**City of Bellevue
Development Services Department
Land Use Division Staff Report**

Proposal Name: Belmont Conservation Short Plat

Proposal Description: Preliminary Conservation Short Plat with Critical Areas Land Use review to subdivide a 1.72 acre site zoned R-7.5 into nine (9) single family lots and two tracts, including a Native Growth Protection area with Category III wetland, buffer averaging and wetland mitigation.

File Numbers: 09-132851-LN and 10-113142-LO

**ROAD & STORM
DRAINAGE PLAN**
1700 - 148th AVE NE
BELLEVUE, WA 98007

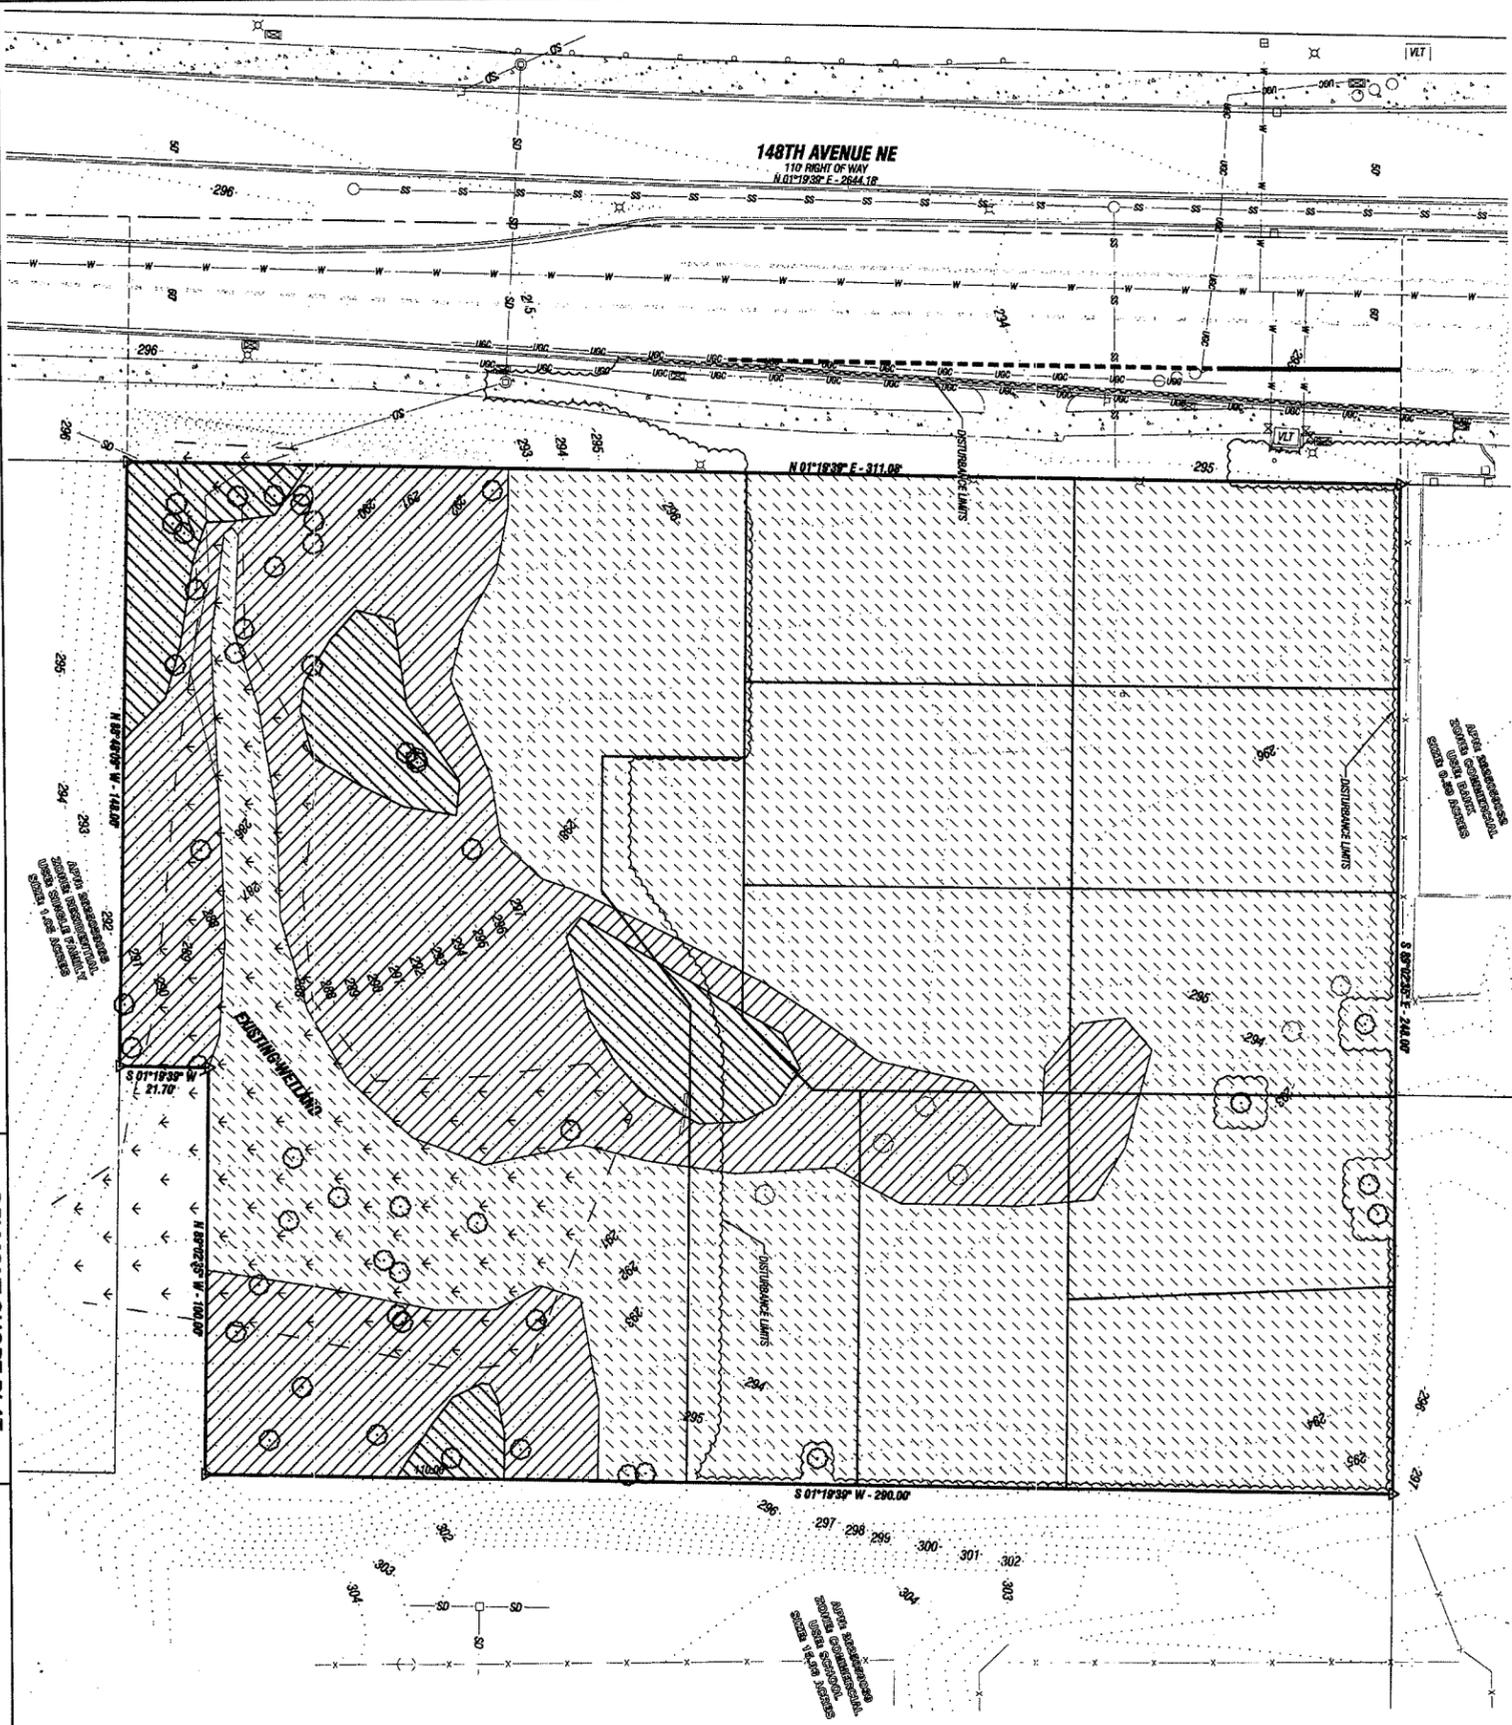
The proposal plans were revised to include a transition lane to allow drivers entering or exiting the site to decelerate and accelerate without significantly affecting the traffic flow on 148th Avenue NE.

The site plan was revised to show the existing sidewalk along 148th Avenue NE to be demolished and reconstructed in a new location to allow for the transition lane. Further, one additional street light was added to the 148th Avenue frontage.

The site plan was revised to increase the width of the hammerhead turn-a-round and related easement (from 21-feet) to 24-feet and 25-feet respectively.

The site plan was revised to include a five (5) foot sidewalk and related easement addition to the north side of the project cul-de-sac.
